Work Order ID 99833

Item Name: 205 Bent Tube

DRAWING NO. D2580	TITLE 205 SKIDTUBE ASSEMBLY	REV. E	DART AEROSPACE LTD ENGINEERING ORDER	D.E.O. NO. D2580-E-1	SHEET NO. SHEET 1 OF 1	SCALE NTS
DRAWN <i>UP</i>	CHECKED <i>ASS</i>	MFG. APPR. <i>ER</i>	APPROVED <i>#</i>	DE APPR. <i>HA</i>		
DATE 11.12.13	DATE 11.12.13	DATE 11.12.13	DATE 11.12.13	DATE 11.12.13

CHANGE ALL C'BORED WELDED CROSSBOLT SPACERS TO SWAGED SPACERS

SECTION B-B
SCALE 5X

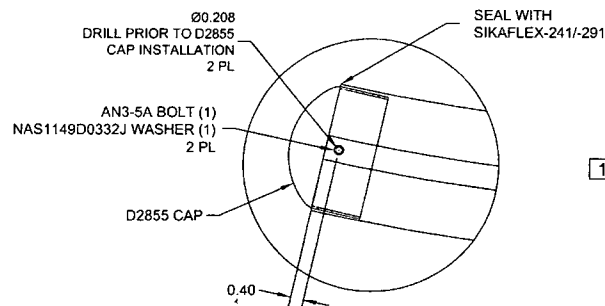
SECTION B-B, SECTION F-F, & SECTION I-I ARE AMENDED AS FOLLOWS
FOR ALL HOLES THAT WERE ORIGINALLY C'BORED:

1. INSERT D4202-1 SPACER, 20 PL (-041) OR 20 PL (-045) OR 25 PL (-047)
2. SWAGE TO Ø0.437 X 1.00 DEEP PER QSI 002
3. TRIM / GRIND FLUSH PER QSI 002

SECTION F-F
SCALE 5X

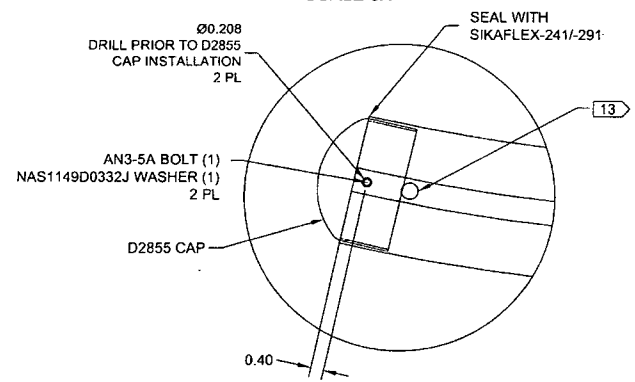
WELD 4X D2579 SPACERS PER DWG
IN LOCATIONS MARKED "NO C'BORE".
REF SHEET 4 OF DWG.

SECTION B-B, F-F, I-I
NOT TO SCALE

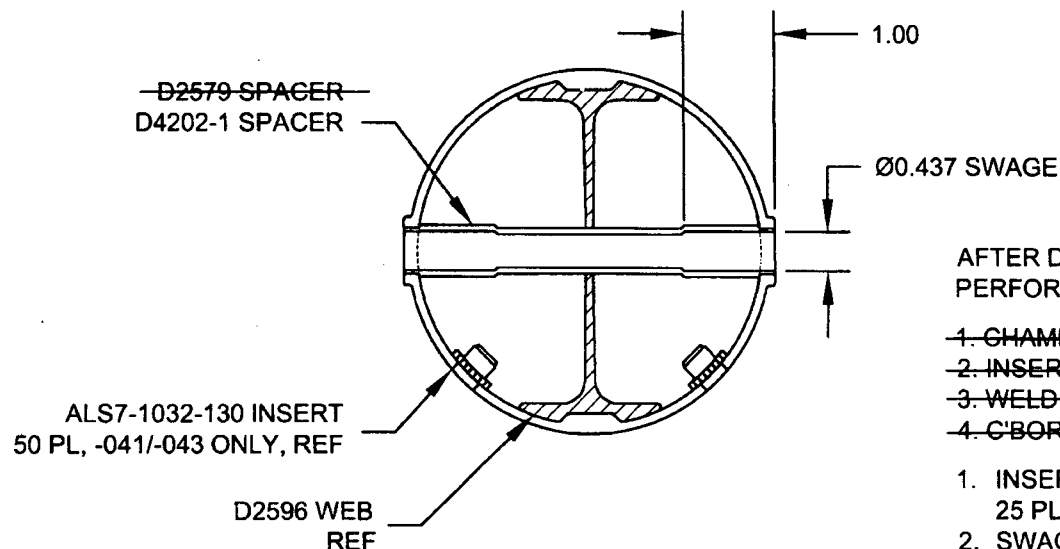
*** FOR -045 SKIDTUBE ONLY:**

- ~~1. CHAMFER HOLE 0.050 X 45°~~
- ~~2. INSERT D2579 SPACER (20 PLACES)~~
- ~~3. WELD INTO PLACE AND GRIND FLUSH~~
- ~~4. C'BORE D2579 SPACER TO Ø0.437 X 1.00 DEEP~~
